PROJECT
CAMPBELL STREET
FOR
Seana Ryan
AT
19 CAMPBELL STREET, BANGALOW NSW
Lot 24 + 25 DP 4358

DRAWING TITLE	NORTH POINT
SITE PLAN	
DRAWING NUMBER	JOB NUMBER
DA.1	126
ISSUE DATE	SCALE AT A3
16/7/20	1:100

DRAWING TITLE	DRAWING NUMBER	ISSUE DATE
ELEVATIONS	DA.5	23/9/20

EAST VIEW

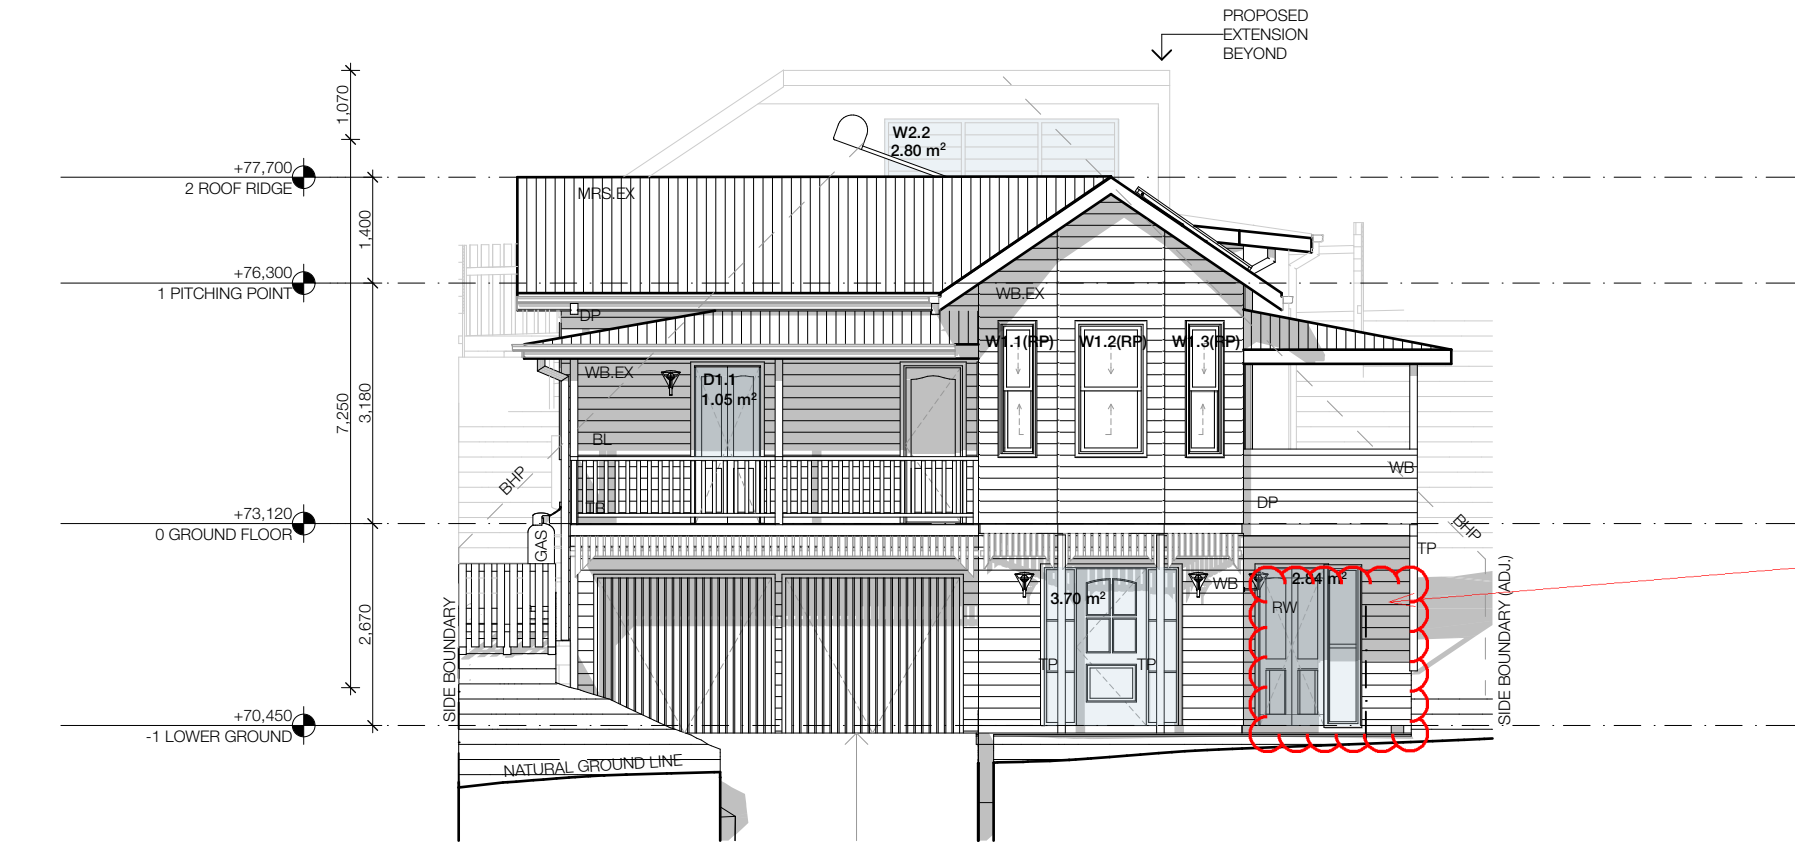
door to be replaced with window

NORTH VIEW

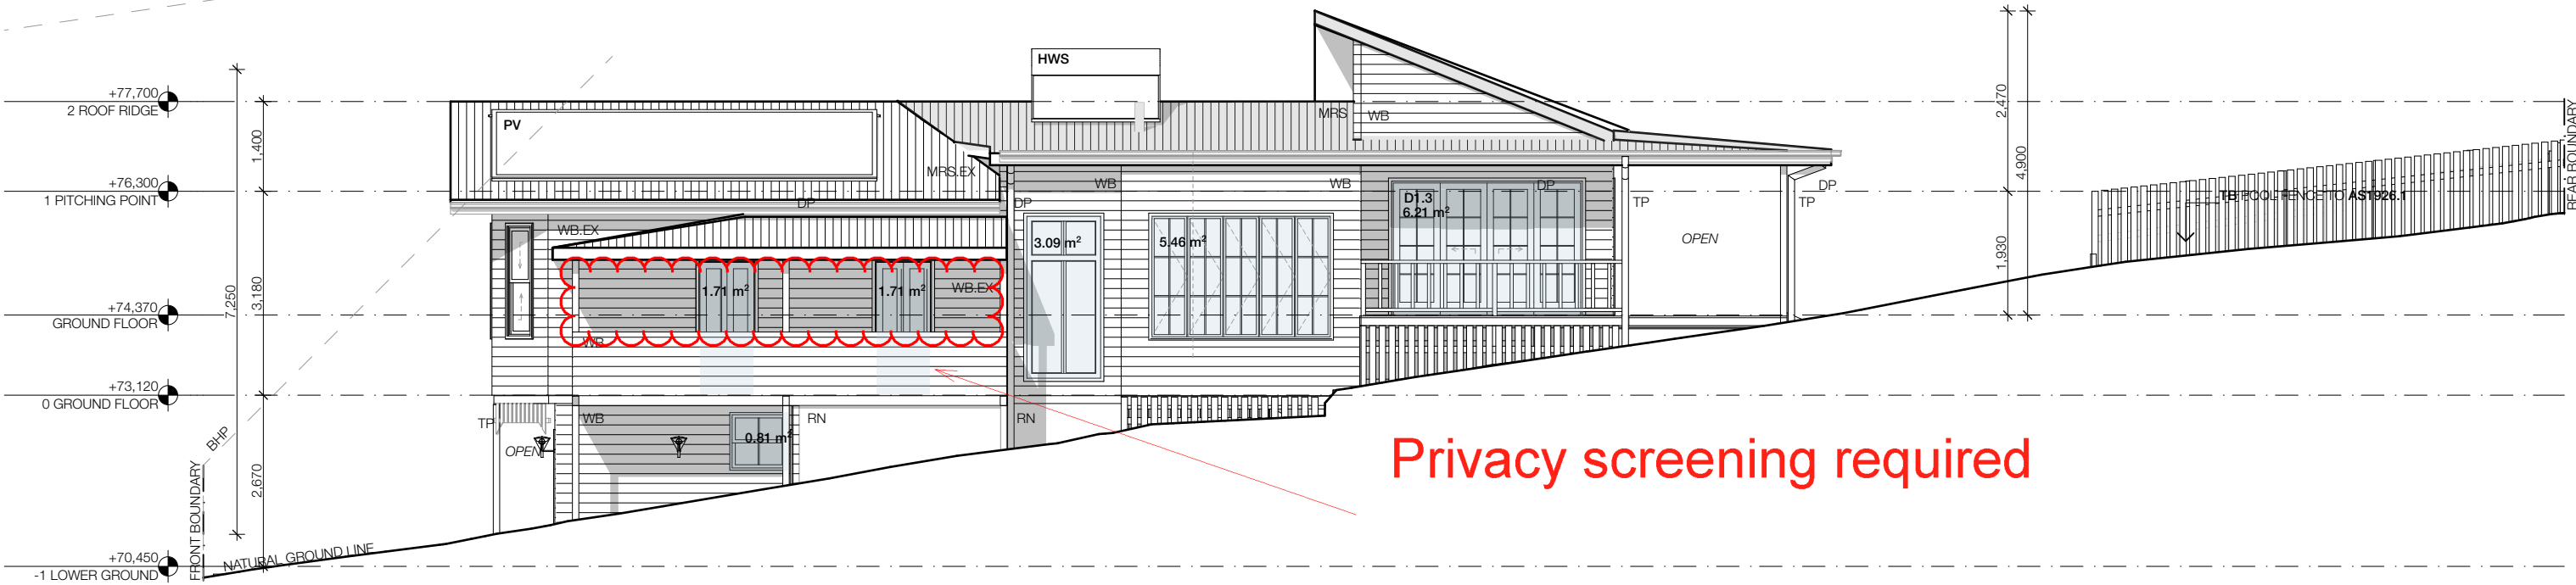
Privacy screening required
